**Re: GE-Pittsfield/Housatonic River Site  
Building 71 and Hill 78 On-Plant Consolidation Areas (GECD200)  
2005 Final Cover Construction for Portion of Building 71 OPCA**

Following receipt of EPA's comments, a teleconference among representatives of EPA and GE was conducted on August 10, 2005 to discuss the EPA's comments. Based on those discussions, GE has revised certain technical drawings and specifications included with the July 15, 2005 letter. Specifically, the following revisions were made:

### PERIMETER BERM FINAL COVER TERMINATION ⑤

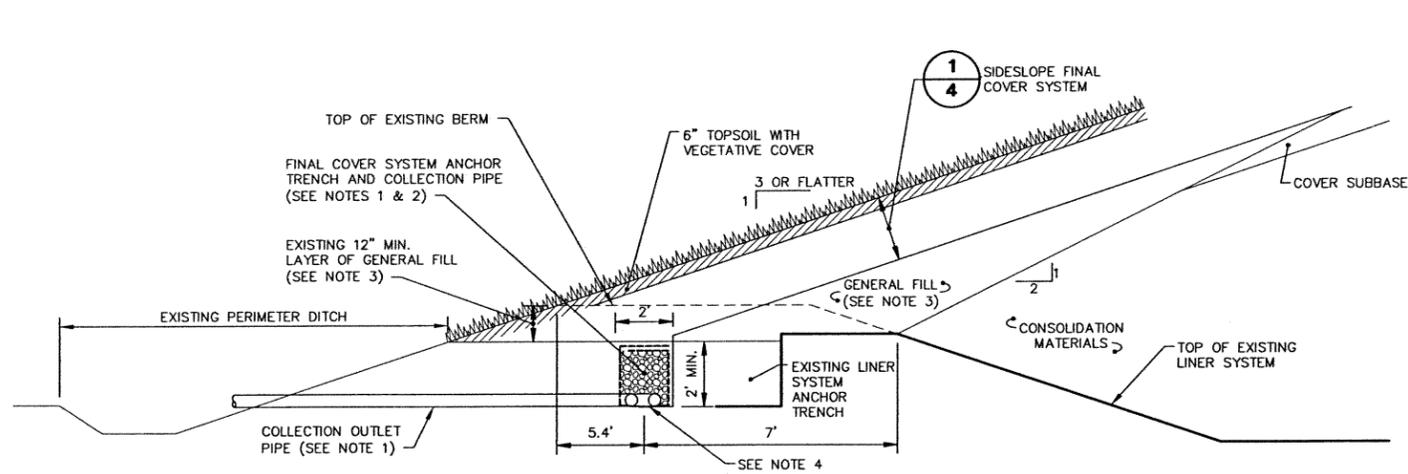
- Technical Drawing 4, Detail 5: a tee connection between the inside final cover collection pipe and the outside cover collection pipe at the collection outlet pipe location was included. This tee connection will allow the inside final cover collection pipe to discharge to the perimeter ditch;

- Technical Drawing 4, Detail 5, Note 1: this note now states that the outlet pipe locations are shown on Drawing 2;
- Technical Drawing 5, Detail 1: permanent erosion control mat is required within the mid-slope swales;

- Technical Drawing 4, Details 5 and 6; and Technical Drawing 5, Detail 5: HDPE coil pipes will be used for the 4-inch diameter perforated and solid wall pipes that are installed in the cover system anchor trench;
- Engineering Calculation - Embankment Ditch Design, Page 2 of 3: channel depth has been confirmed throughout the entire length of the ditch and is sufficient under the specified conditions;
- Technical Drawing 4, Detail 6 and Technical Drawing 5, Detail 5: permanent erosion control mat is required within the embankment ditch; and
- Engineering Calculation - Final Cover (Veneer) Stability Analysis: a minimum acceptable factor of safety of 1.5 is used.

- THE INSIDE FINAL COVER COLLECTION PIPE WILL BE CONNECTED TO THE OUTER FINAL COVER COLLECTION PIPE USING A TEE CONNECTION AT THE COLLECTION OUTLET PIPE LOCATION.
